Montrose Boulevard Project Community Feedback

Below are all the questions received on or before February 03, 2023, from members of the public regarding the Montrose Boulevard public meeting on January 23, 2022. The responses provided are to the best knowledge of the design engineers and consultants at this point in time during the preliminary engineering phase of the project. This document, as well as electronic versions of the presentation boards from the January 23, 2023, meeting will be made available at montrosehtx.org.

Exhibit 2.3L Corridor Crash Rates

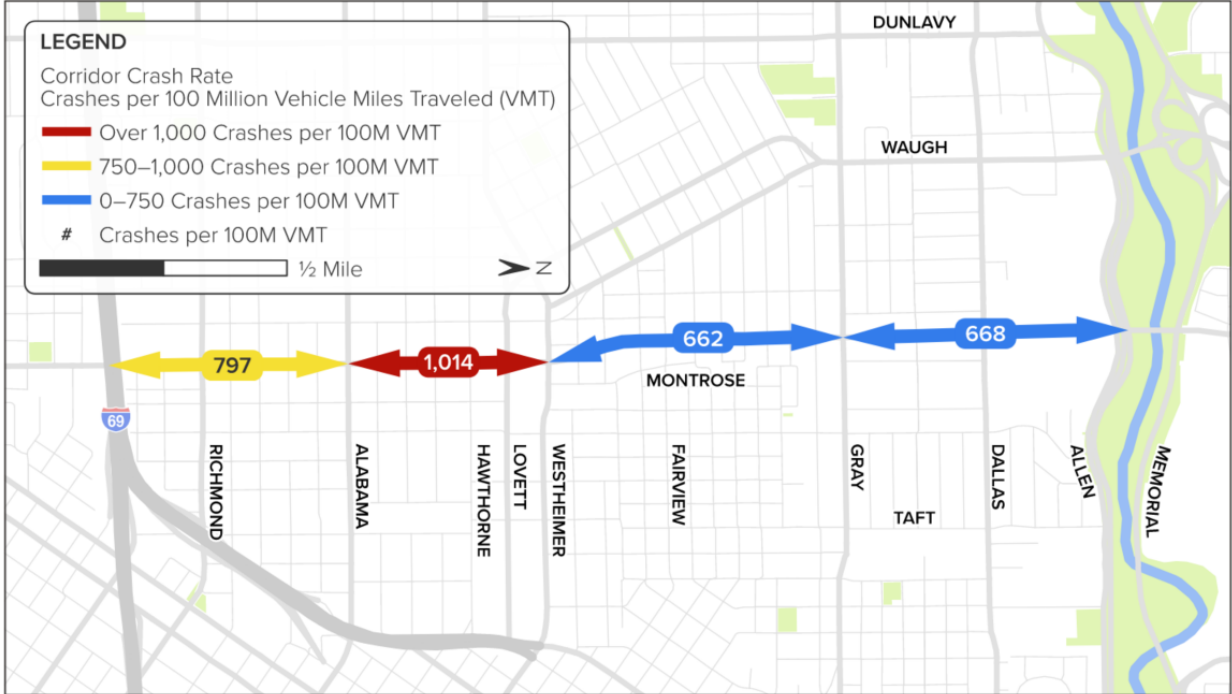
i.) Given that the Montrose to Dallas block is 1/4 mile and given that the segment is not currently tree median/blvd and given there is a negligible population of viable trees currently on the west block and given the shown Metro Boost plan does not contemplate a mid-block stop for this segment and given that the land use on the west side of Montrose is primarily a cemetery and given that the vehicle ingress/egress to said cemetery is within 180 ft of W Dallas and other pedestrian access to that property is not available mid-block and given that there are limited sources of pedestrian traffic that must or will be induced to use a whole block west Montrose blvd walkway...

Crash locations were studied in the Design Concept Report. Wide sidewalks, reflective crosswalk pavement markings, new traffic signals with leading pedestrian intervals, shared use path (Dallas to Allen Pkwy), enhanced crossings (via closed medians for pedestrian and bike crossings) are being installed, and a speed limit reduction to 30-mph are all oriented towards the City of Houston Vision Zero Action Plan. The roadway will be much safer than in existing conditions. A few exhibits are below that show the crash data.
